TO: Programs, Projects, and Operations Subcommittee
FROM: Eric Williams, Natural Resources Planner
SUBJECT: Hell Creek Grade Control Stabilization, Change Order 1
DATE: August 5, 2016

CHANGEDATE AUGUST 4, 2016**ORDER**OWNER PAPIO-MISSOURI RIVER NRDHELL CREEK GRADE CONTROL
STABILIZATION (AT CONFLUENCE WITH
PROJECT WEST PAPILLION CREEK)JOB NO. 115048-01CHANGE ORDER NO. 1CONTRACTOR: VALLEY CORPORATION
28001 IDA CIRCLE
VALLEY, NEBRASKA 68064

REVISION TO THE CONTRACT BID ITEM

NOTES:

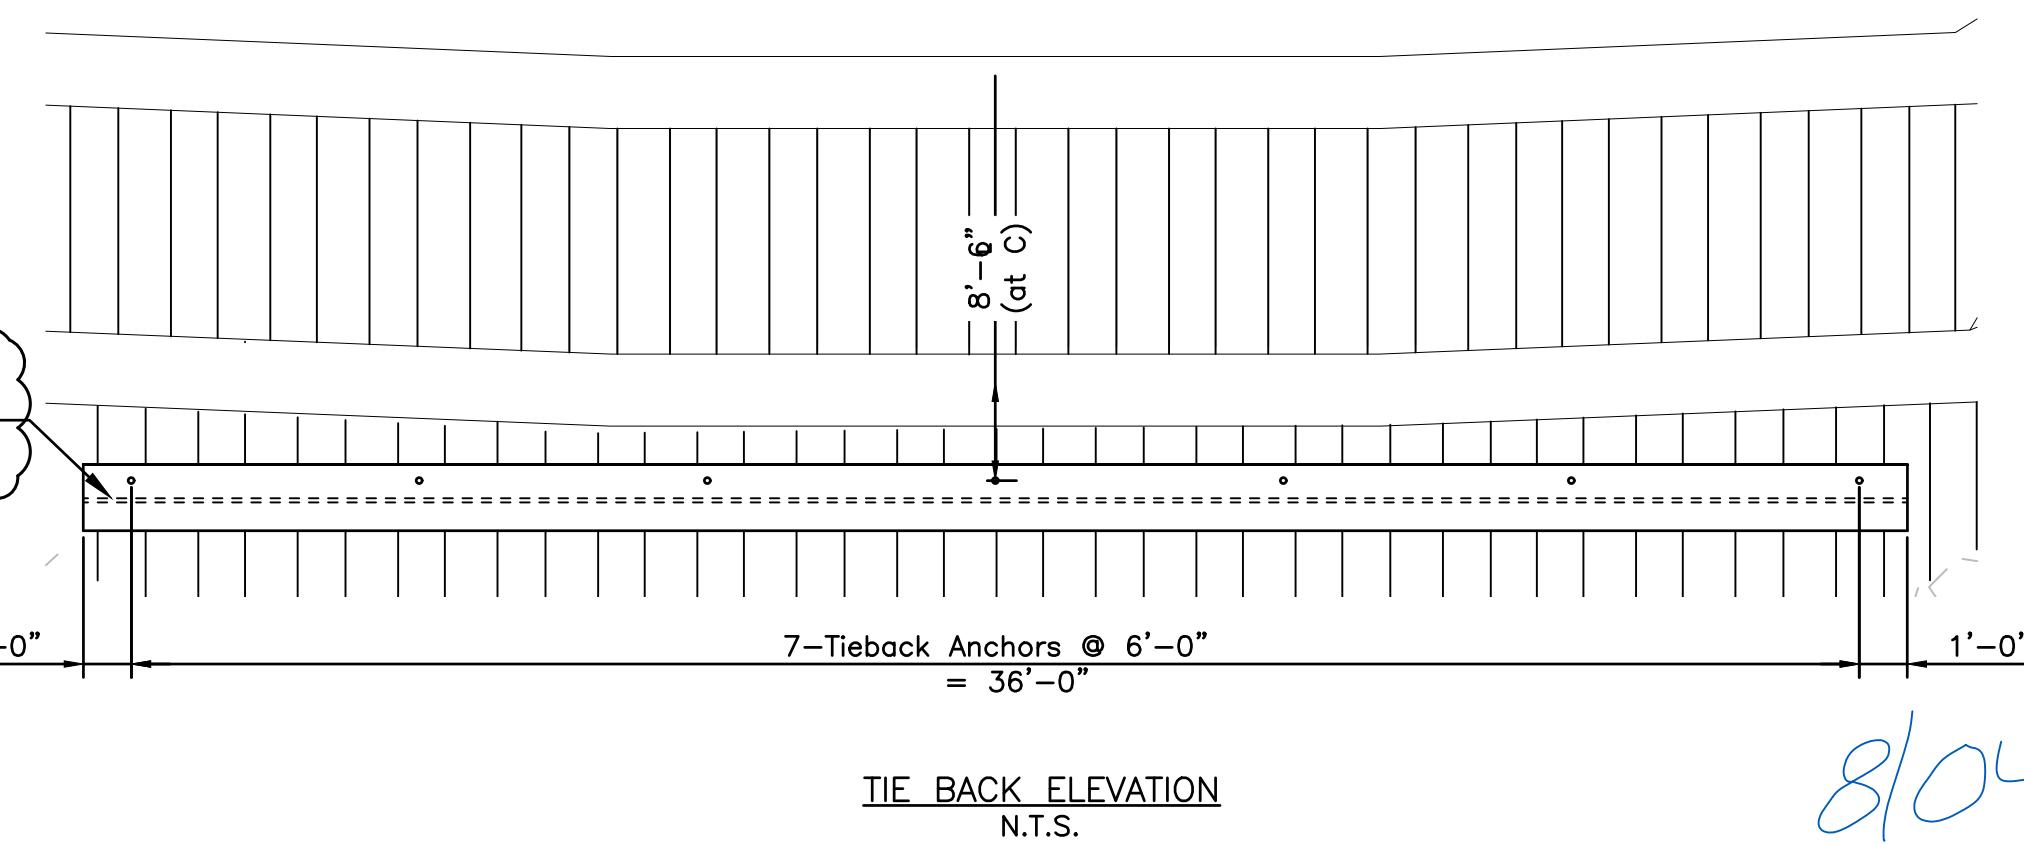
General Notes and Tabulations (Sheet 2 of 14)
Site Plan and Profile (Sheet 5 of 14)
Bridge Structure, Other Details (Sheet 8 of 14)

17. TIE-BACK SYSTEM CORROSION PROTECTION: The contractor shall apply corrosion protection to the tie back system as noted in the PLANS. Payment at the contract lump sum for "Tie-Back System Corrosion Protection" shall be full compensation for furnishing all labor, materials, equipment, tools and incidentals necessary to complete the work.

1. Tie-backs shall have a capacity of 56 kips each. At the contractor's option, tie-backs may be connected to the upstream sheet pile. alternately, an intermediate dead-man anchor block may be installed, or other mechanical means as approved by the engineer.

5. All steel components of the tie-back system not embedded in concrete shall be hot-dip galvanized to a minimum zinc coating thickness of 6.0 mils. Galvanization shall take place after fabrication prior to erection. Inspect galvanization after erection and touch up with galvanizing spray as required. This includes but is not limited to anchor rods, soldier beams, walers, and tie-back connections.

6. After installation, exposed anchorage components shall be coated with coal tar epoxy.

SHEET PILE TIE BACK AND CONNECTION DETAILS
 STRUCTURAL
 HELL CREEK GRADE CONTROL STABILIZATION
 PAPIILLION, NEBRASKA
 2016

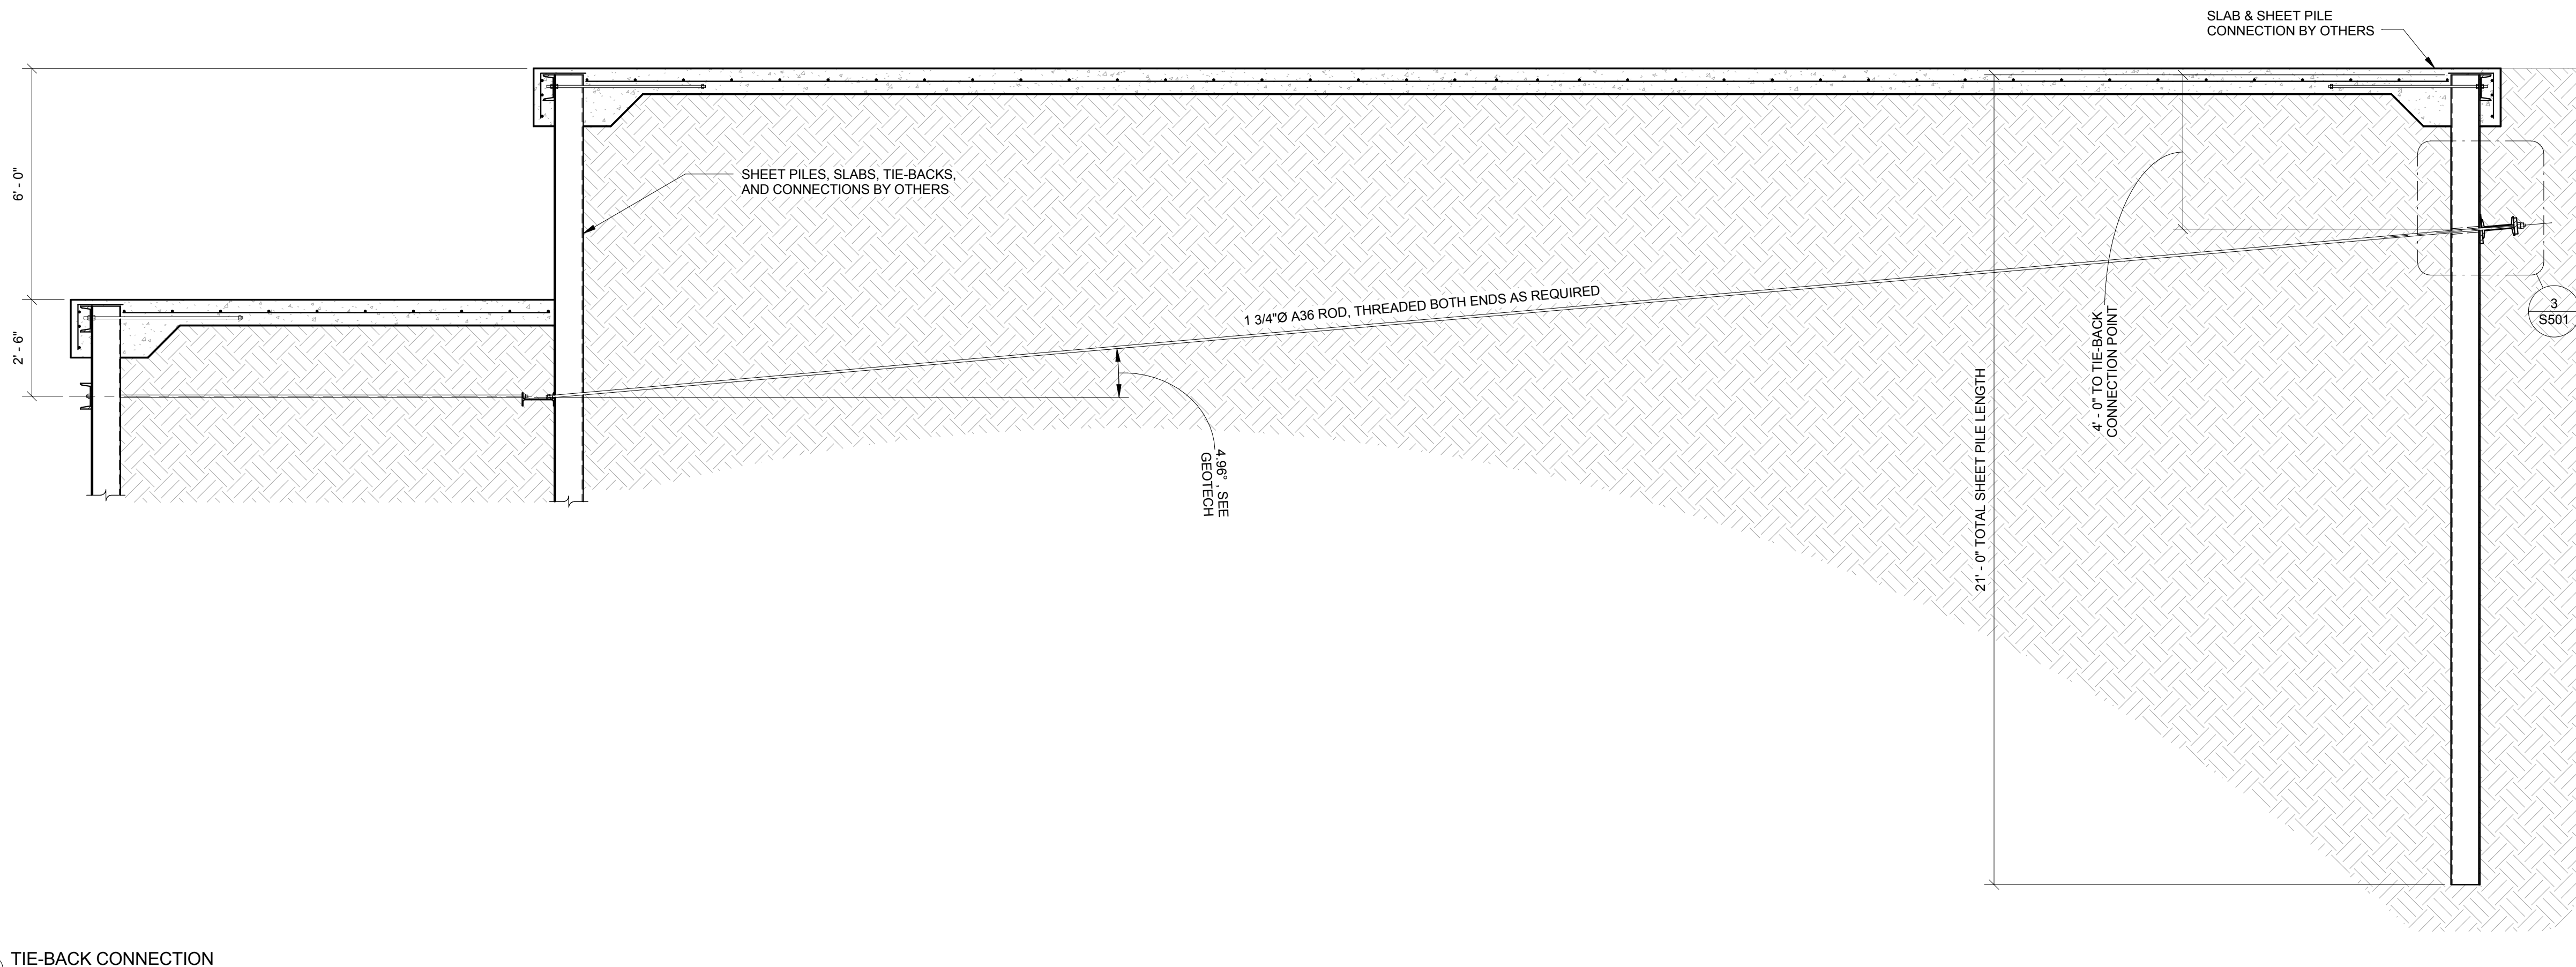
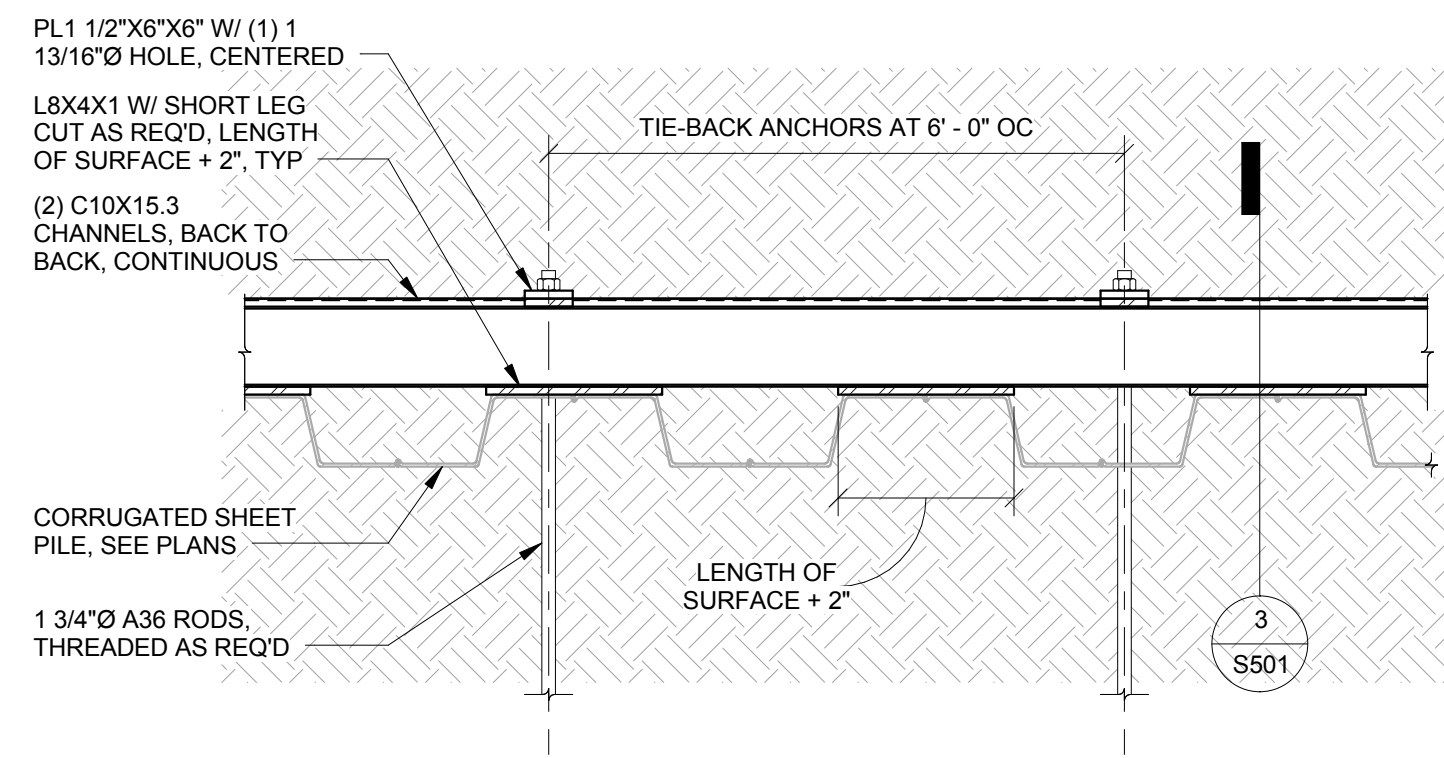
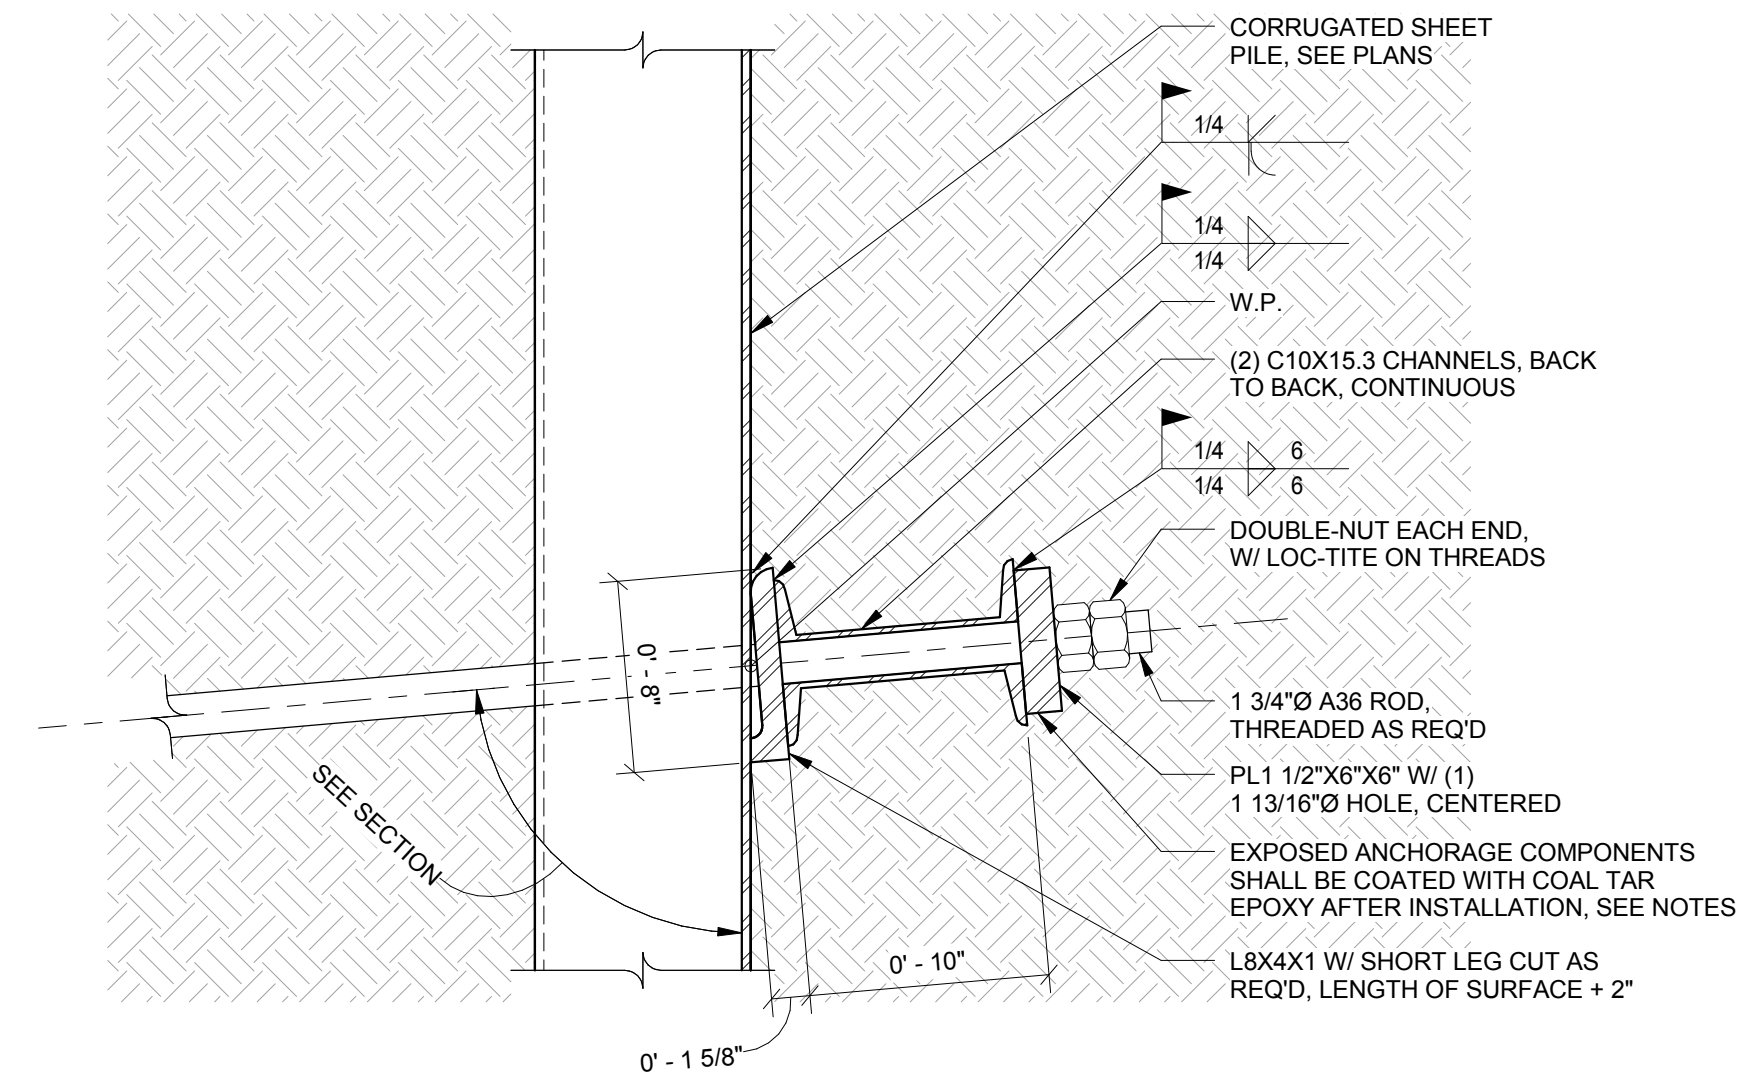
Add the enclosed drawings to the plan set including:

Sheet Pile Tie Back and Connection Details (Sheet 1 of 1)

16. TIE-BACK CONNECTION MODIFICATIONS: Payment at the contract lump sum for "Tie-Back Connection Modifications" shall be full compensation for furnishing all labor, materials, equipment, tools and incidentals to construct the proposed modifications to the tie-back system, including structural members, as indicated in the plans.

- ALL STEEL COMPONENTS OF TIE-BACK SYSTEM SHALL BE HOT-DIP GALVANIZED TO A MINIMUM ZINC COATING THICKNESS OF 6.0 MILS. GALVANIZATION SHALL TAKE PLACE AFTER FABRICATION, AND PRIOR TO ERECTION. INSPECT GALVANIZATION AFTER ERECTION AND TOUCH UP WITH GALVANIZING SPRAY AS REQUIRED.
- AFTER INSTALLATION, EXPOSED ANCHORAGE COMPONENTS SHALL BE COATED WITH COAL TAR EPOXY.
- STEEL GRADES FOR COMPONENTS ON THIS SHEET SHALL BE AS FOLLOWS:

ANGLES	ASTM A36 STEEL
CHANNELS	ASTM A36 STEEL
PLATES	ASTM A36 STEEL
NUTS	ASTM A563 STEEL
RODS	ASTM A36 STEEL
